**MONTGOMERY COUNTY HISTORIC PRESERVATION COMMISSION**  
**STAFF REPORT**

<b>Address:</b>	11 Quincy St., Chevy Chase	<b>Meeting Date:</b>	4/23/2025
<b>Resource:</b>	Non-Contributing Resource Chevy Chase Village Historic District	<b>Report Date:</b>	4/16/2025
<b>Project Contact:</b>	Neal Thomson, Architect	<b>Public Notice:</b>	4/9/2025
<b>Review:</b>	HAWP	<b>Staff:</b>	Dan Bruechert
<b>Permit Number:</b>	1111156	<b>Tax Credit:</b>	n/a
<b>Proposal:</b>	Demolition of existing house, construction of new single-family house and garage, and tree removal

**Proposed Site Plan**  
Scale: 1/16" = 1'-0"  
**Little Residence**  
**11 Quincy Street**

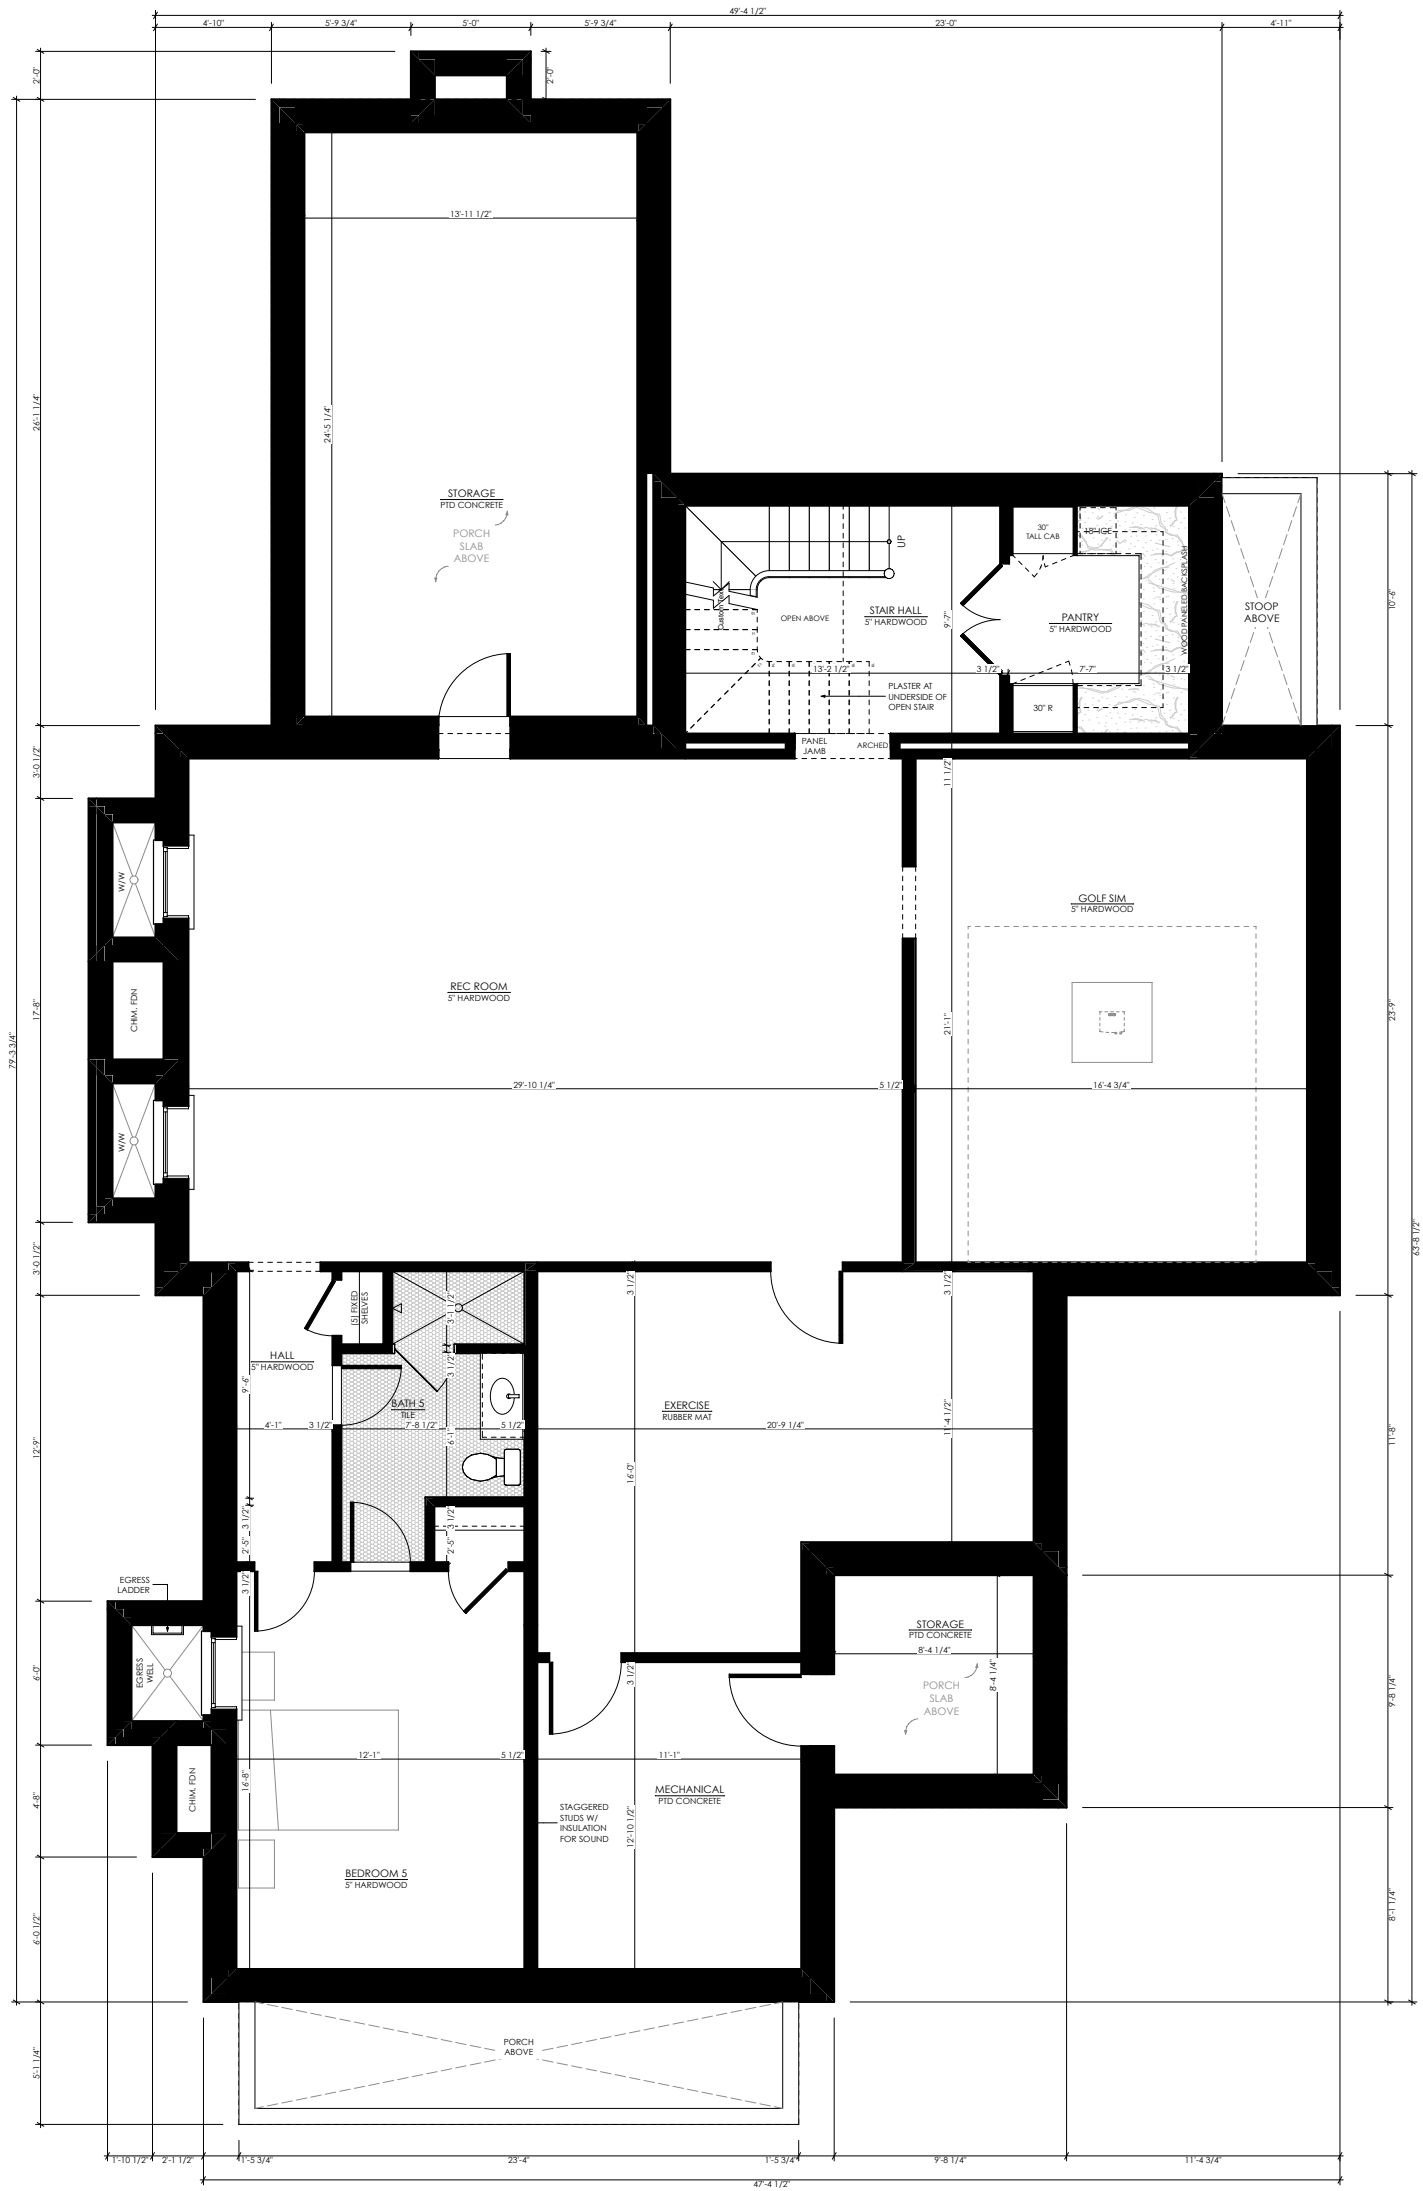
At the rear of the house, the applicant proposes to install a stone terrace with a brick paved landing and stairs. The terrace measures 6' 7" × 26' (six feet, seven inches deep by twenty-six feet wide). Other hardscaping changes include repairing the existing asphalt driveway and installing a brick paved parking court in the rear. The parking court measures 22' 7" × 24' (twenty-two feet, seven inches wide by twenty-four feet deep). Lastly, the applicants proposes to install a new brick front walk from sidewalk to the front entrance. Montgomery County and Chevy Chase Village calculate lot coverage differently, however, the proposed total lot coverage is approximately 4% (four percent) less than the maximum allowed under zoning.

The applicant proposes to remove 7 (seven) trees larger than 6" d.b.h. (six inches diameter at breast height). At the front of the property there is a 13" (thirteen inch) Holly tree. All of the remaining trees are either at the side of the house, in the case of the 20" (twenty inch) cedar, or at the rear of the property

such as the 25" (twenty-five inch) maple. The applicant has provided a landscape plan that shows substantial additional plantings on site; however, no species were identified on the plan.

Along the west (left) property line, the applicants propose to install a 7' (seven foot) privacy fence. Elevations for the fence were not provided.

Staff finds most of the proposed hardscaping will not be at all visible from the public right-of-way. While asphalt is not usually a preferred material within the Chevy Chase Village Historic District, Staff finds the applicant proposes to repair the existing driveway, and that will not substantially change the character of the site. Staff finds the brick parking court and stone terrace are both compatible with the character of the site and surrounding historic district.

It is unfortunate that the two largest trees on site are in the location of proposed construction. The screened-in porch is proposed in the location of the 24" (twenty-four inch) maple and 20" (twenty inch) cedar is in the location of the proposed driveway extension. Staff notes, the maple is located behind the existing house and does not substantially contribute to the character of the streetscape; and the driveway cannot be accommodated anywhere else on site. Staff finds that landscape plans at this stage are often largely illustrative and suspects that to be the case in this instance. Staff recommends the HPC permit the removal of the proposed trees, finding they will not significantly detract from the character of the streetscape or surrounding district, and add a condition that the applicant must return for the HPC's review and approval of a landscape plan that includes the planting of two hardwood canopy species.

Lastly, Staff finds the information regarding the proposed privacy fence is inadequate to render a finding and encourages the applicant to submit the fence information with the additional tree removal information discussed above. Staff notes that fences taller than 6' (six feet) are rarely approved in the Chevy Chase Village Historic District as they can impair the district's open park-like setting. Staff recommends the approval of this HAWP not extend to any fencing on site.

1. Final fencing and landscape plans, which include the planting of two hardwood canopy species must be submitted for review as a separate HAWP.

Left Elevation  
Scale: 1/8" = 1'-0"  
Little Residence  
11 Quincy Street  
31 17

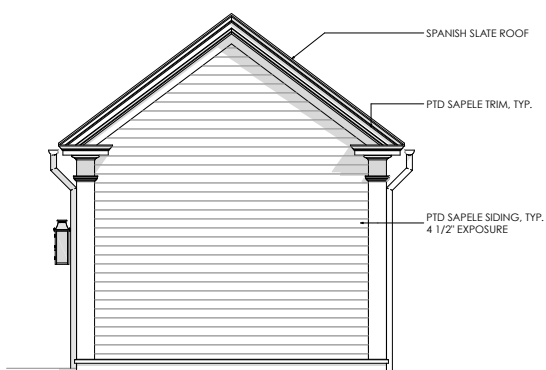
The left elevation eliminated the attic dormer that some commissioners identified as 'awkward.' That elevation is otherwise unchanged.

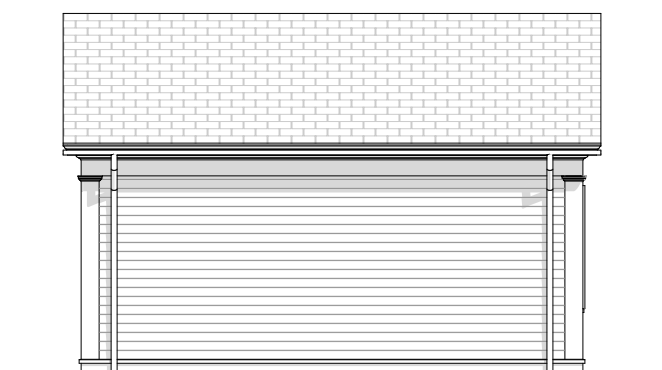
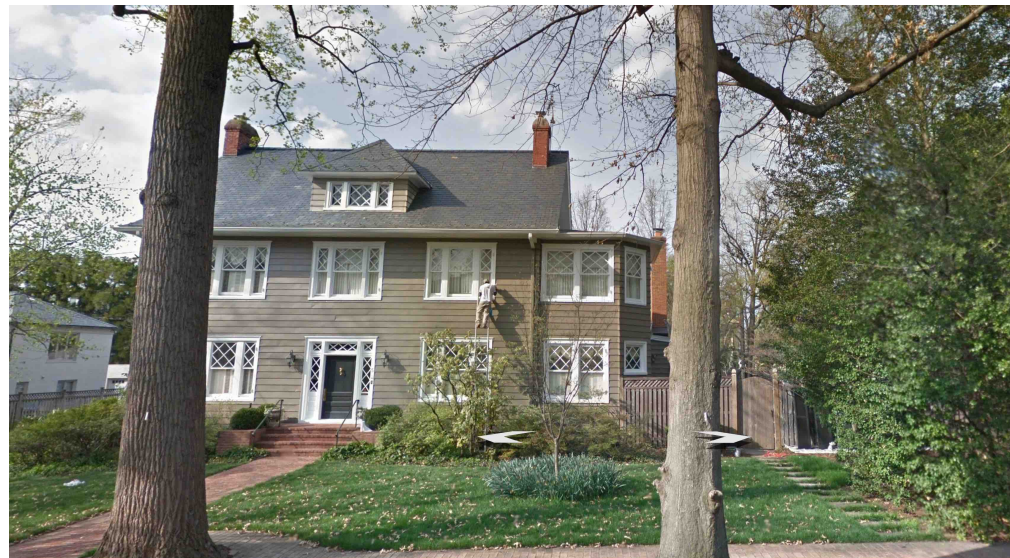
In the northwest (right rear) corner of the property the applicant proposes to construct a garage. The building will be 20'8" × 12'8" (twenty feet, nine inches wide by twelve feet, eight inches deep) and will be constructed to compliment the proposed house with matching wood siding, a wood 6/6 sash window, wood carriage door, slate roof, and wood trim. Most of the garage will be obscured by the proposed house. The proposed garage is setback by 5'3" (five feet, three inches) from the rear and side property boundaries.

Staff finds the proposed garage is compatible in size with the property and surrounding streetscape. The design and materials are all consistent with what is proposed for the new house as directed by the *Design Guidelines*. Additionally, Staff finds the garage will not overwhelm the character of the site or surrounding district and will have limited visibility from the public right-of-way.

Streetscape Study  
Scale: 1/16" = 1'-0"  
Little Residence  
11 Quincy Street  
33

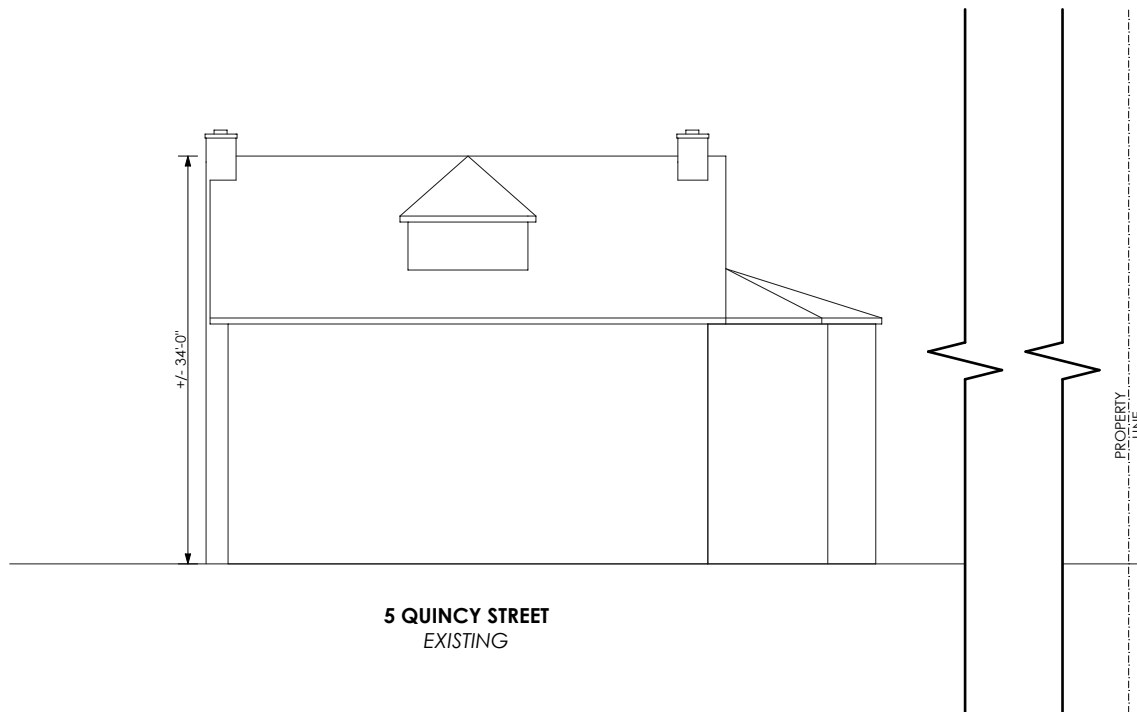
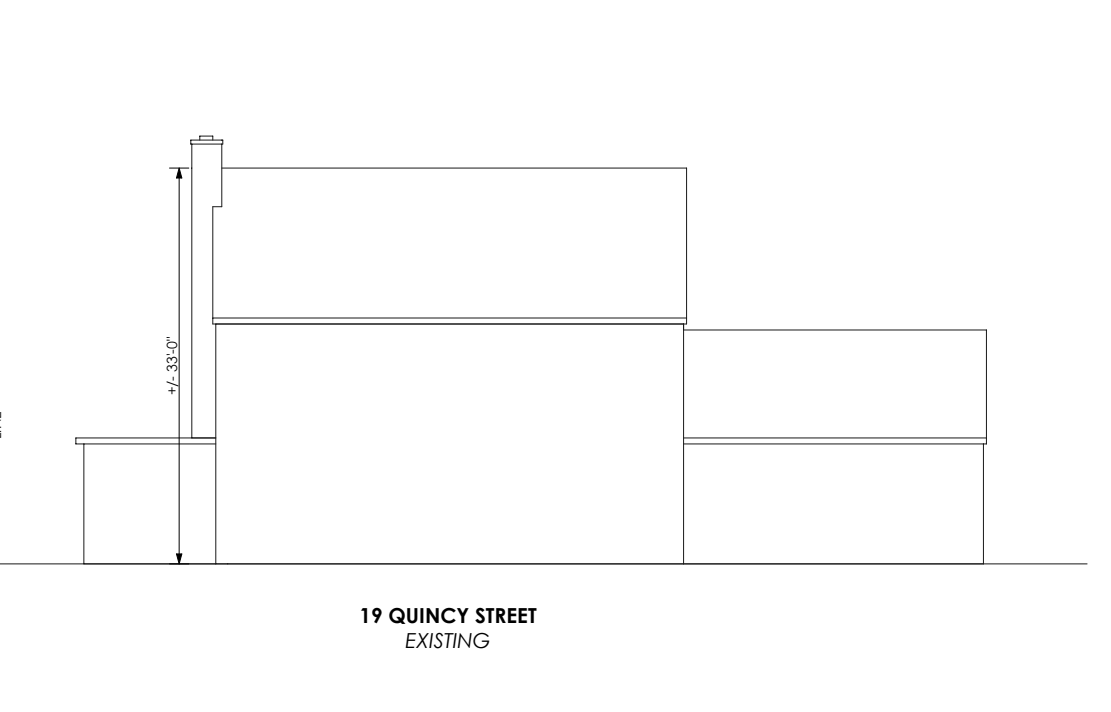
The applicant provided a streetscape study to compare the mass of the subject property to its neighbors at 5 Quincy St. and 19 Quincy St. While the streetscape does not show the spaces between the houses as accurately scaled, it does help to demonstrate that the proposed house is consistent with the massing of its neighbors. While the house is large, it is not out of scale with its neighbors and, as the HPC commented during the Preliminary Consultation, the massing is successfully broken up so that the house does not read as a massive structure. The proposed house is slightly taller than its neighbors, but Staff does not find the 6" (six inch) and 18" (eighteen inch) height difference will substantially impact the character of the surrounding streetscape.

Staff concurs with the HPC's finding from the Preliminary Consultation that the proposed house design is compatible with the character of the district. The additional information regarding the setbacks and overall dimensions leads Staff to conclude that the proposed house will blend in with the existing streetscape as required by the *Design Guidelines*.
